1966 Corvette: Product Data Book: Radiator Grille Supports

Subject: Radiator Grille Supports

Model and Year: 1966 Corvette

Date: March 22, 1966

FIGURE 1

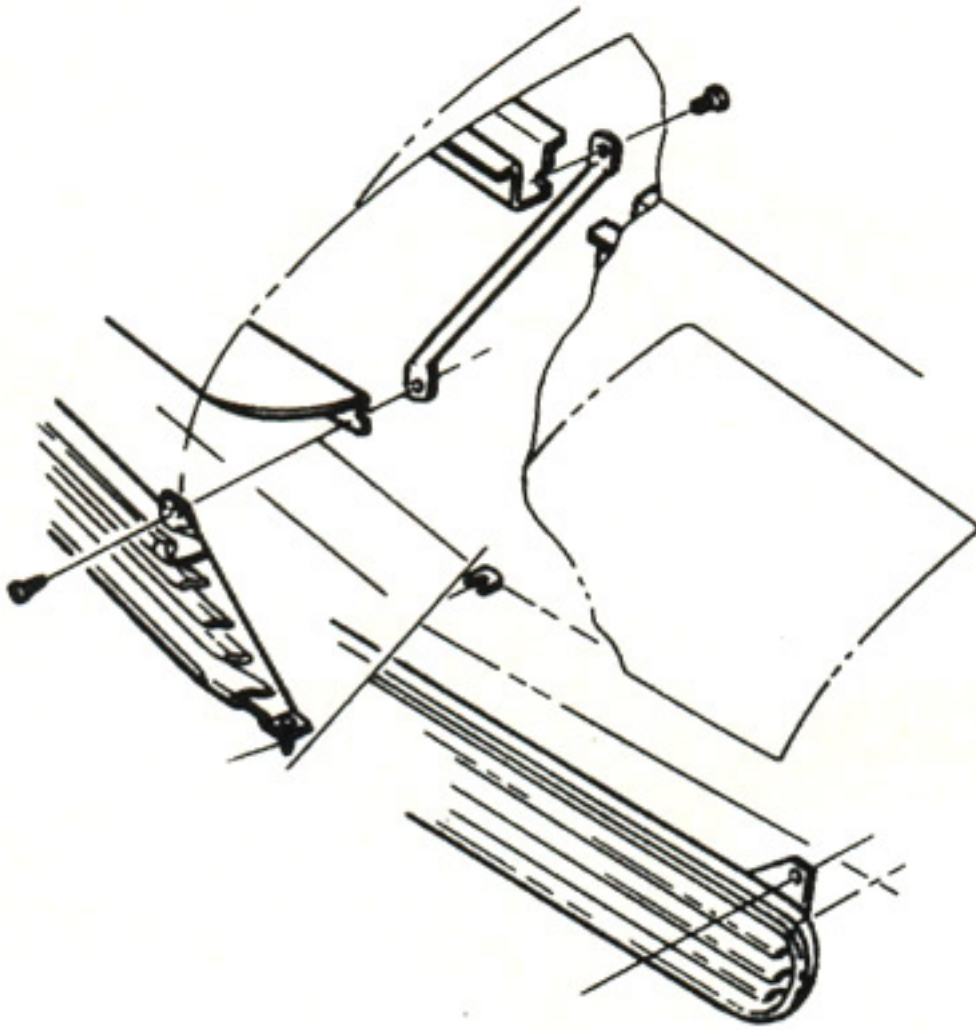
When 1966 Corvettes are driven on rough surface roads, there is a possibility the outer grille supports may break at the body attaching locations.

In production, starting with serial #S115499, the radiator grille supports are of an improved design and a radiator support rod has been added at the center. This is similar to 1965 production.

If outer grille support breakage is encountered on vehicles built prior to serial #S115499, install radiator grille supports, Part No. 3897389, and center radiator support rod, Part No. 3897387. (fig. 1).
